Subject: MOD 2020/0498-70 Lauderdale Avenue, Fairlight- Submission to s 455

Subject: MOD 2020/0498 - 70 Lauderdale Avenue, Fairlight - Objection Submission to Section 455

70 LAUDERDALE AVENUE, FAIRLIGHT NSW 2094

01 LOWER GROUND PLAN
1:100

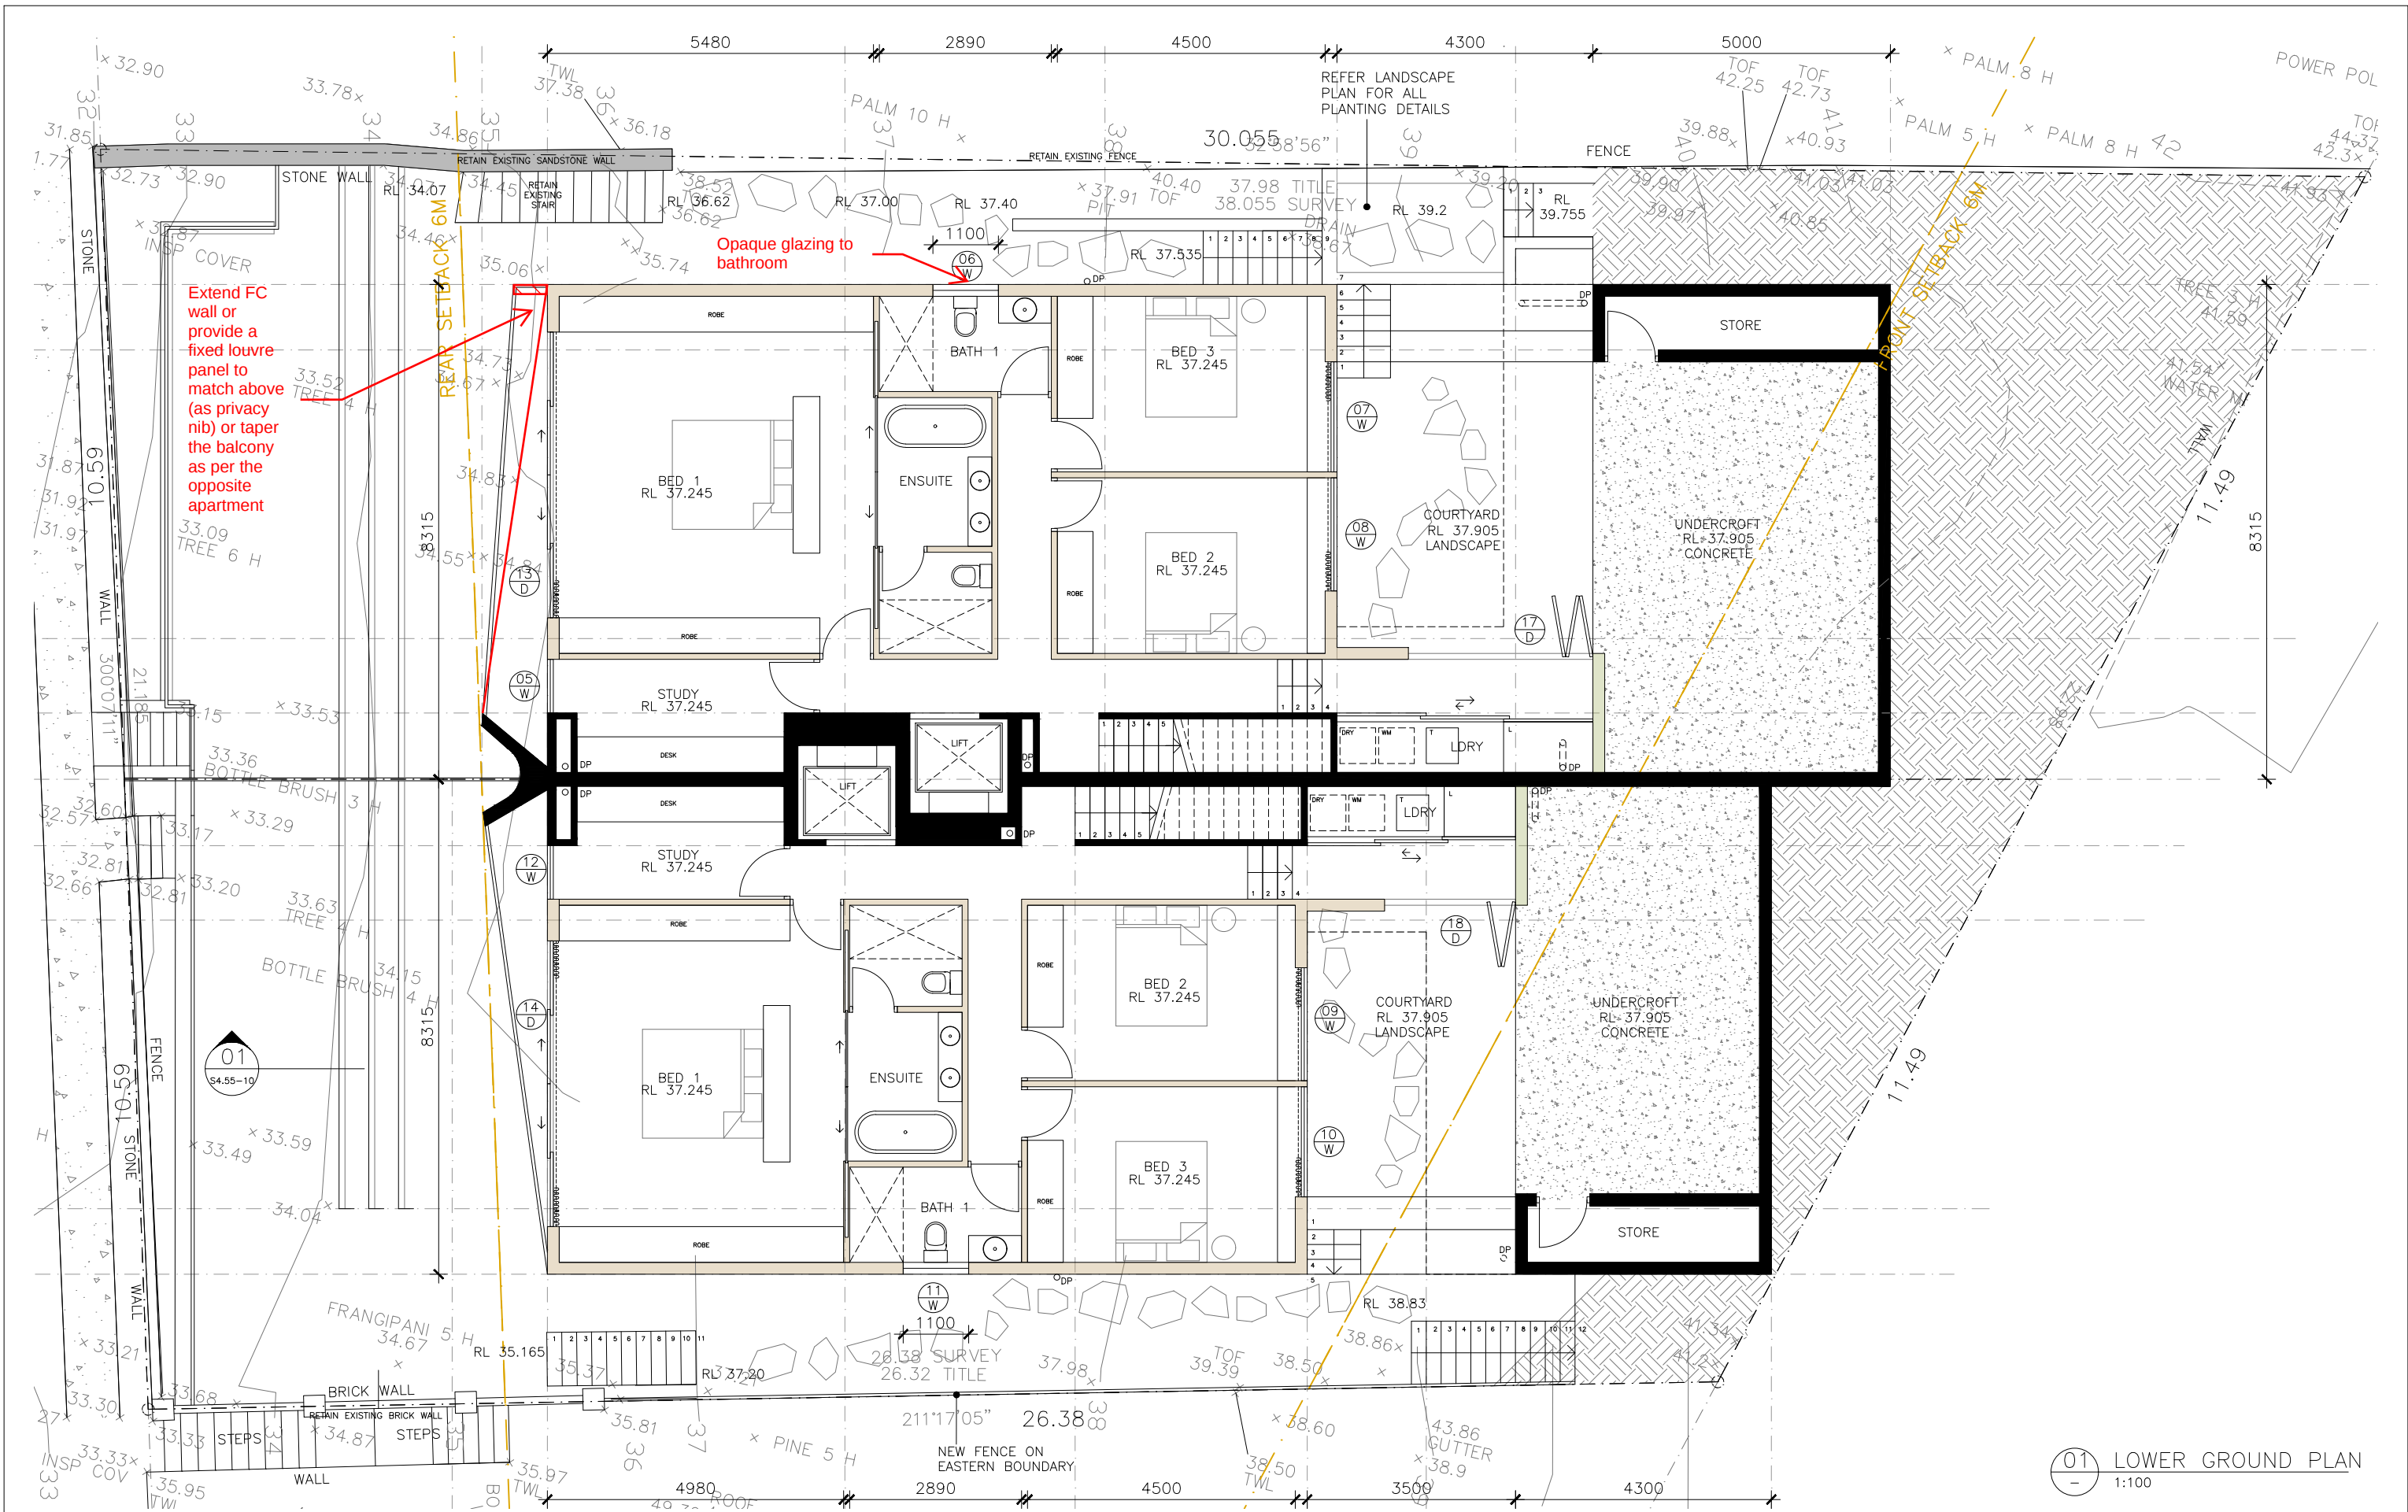
The proposal includes a new lower level western wall bathroom window facing our home. In fairness, it should be a condition of any approval that the bathroom window be opaque glass and that there not be any fan exhaust directed toward our home. The proposed bathroom window is approximately opposite our entrance.

We enclose marked up plans (in red). We have marked opaque glass for the bathroom window. This specification and that there be no exhaust fan should be added Conditions of any approval. The attached marked up plans also offer alternatives for resolution of the privacy issue with the proposed south/western open balcony. These include: a fixed (closed) wall; fixed angled louvres matching those above and in the Approved Plans and Condition 24; or a tapered balcony matching the eastern side of the development.

1. Install privacy screens where appropriate to address your concerns as raised below;
2. Install an opaque western bathroom window.

01 ELEVATION WEST
1:100

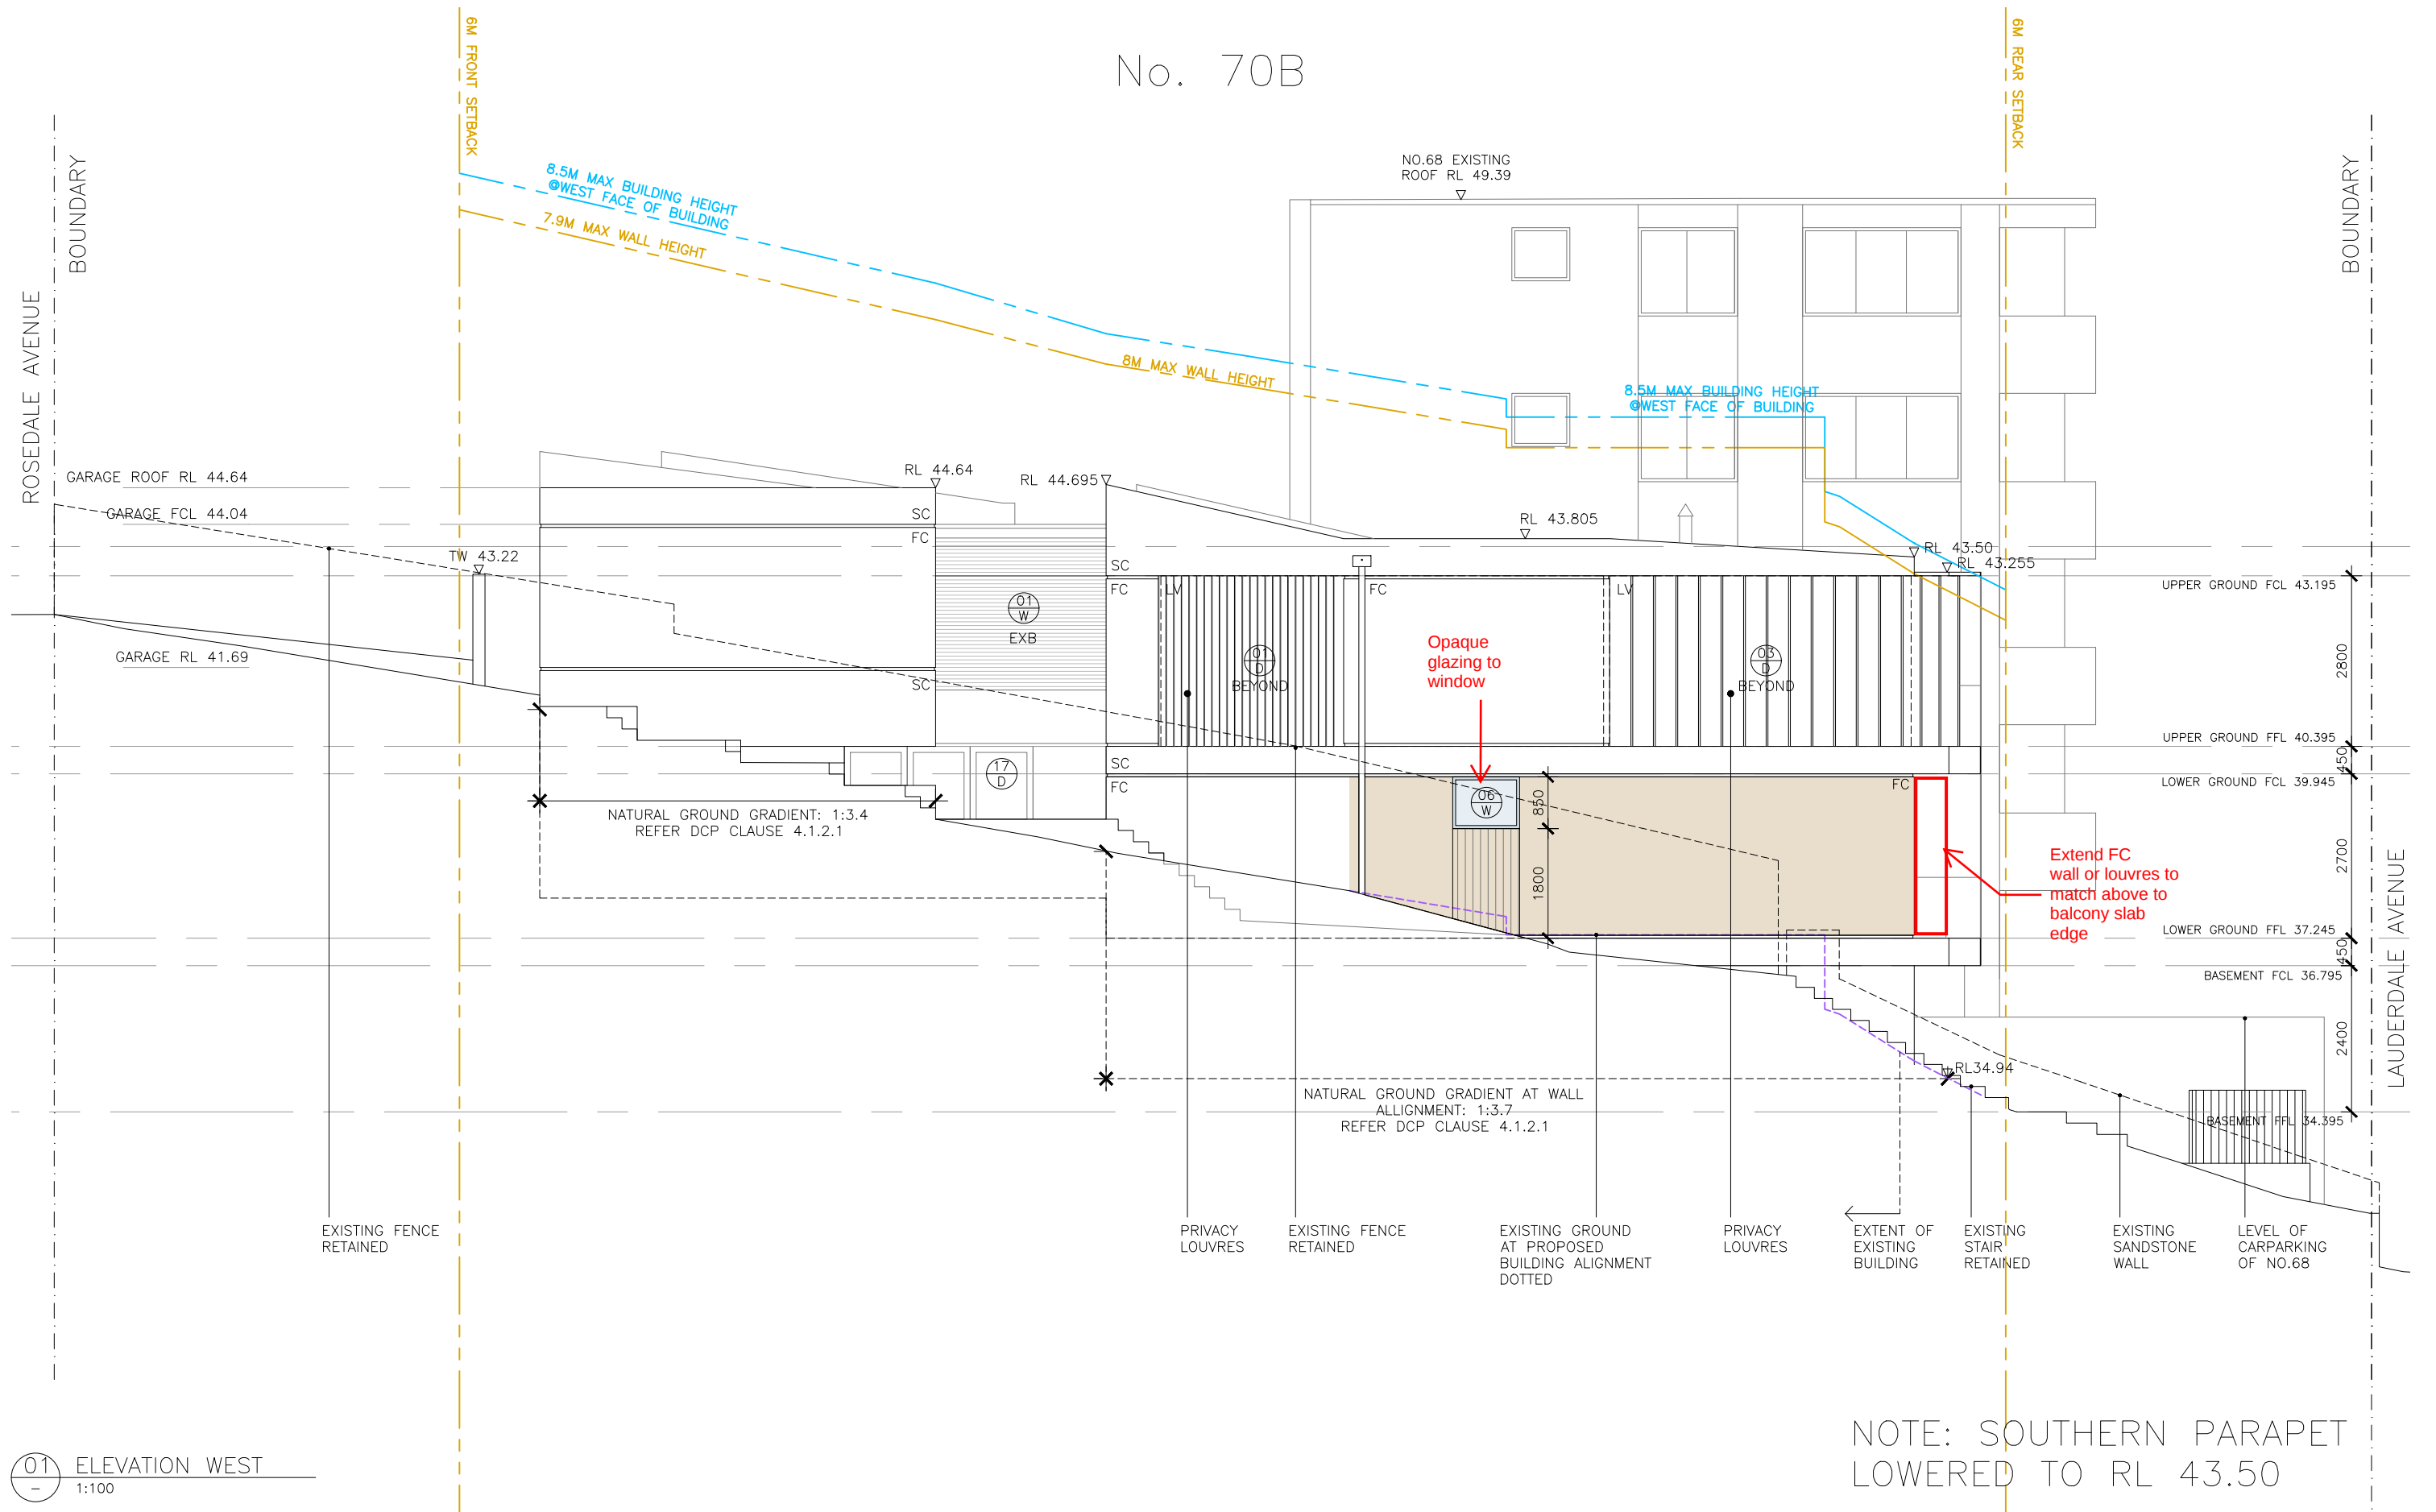
- Fixed, angled louvres be installed at the western extremity of the southern/lower floor balcony, matching louvres to western extremity of upper floor southern balcony so as to provide privacy against overlooking 72 Lauderdale Avenue, in accordance with Condition of Approval Consent 24;
- Bathroom window to the western external wall must be opaque glass; and
- Western bathroom fan to be internal with western external wall bathroom fan exhaust vent at its highest point to be not more than 1.6m above existing ground level (below dividing fence height) and covered by an external grille/ hood directing exhausted air/ steam and noise downward.

The proposed variation is contrary to the agreement reached between the developer and ourselves of which we wrote in our submissions that the western face not look into our property. Condition 24 of the Approval requires fixed, angled louvres protecting our privacy. The proposal includes an open balcony at the southern extension of the proposed new lower level western wall. The proposed new balcony would look directly over our property and the entrance to our home. The open balcony is a proposal to breach the intent of Condition 24 and our agreement with the developer upon the basis of which we compromised other objections.

With respect to your concern raised regarding – “no bathroom fan exhausting in the direction of our property” – we have discussed this with our builder and propose the following solution. As we are compelled to have a bathroom vent to comply with BASIX requirements, we propose:

- Attaching an external grille to the fan (similar to the photo below) which will vent down to the ground away from your property

- Locating it below the level of the fence line, further removing it from your properties entry point.

We understand this to mean that the developer accepts that they will install fixed, angled louvres at the lower level of the western extremity of the southern terrace. We understand that they agree the bathroom window will be opaque.
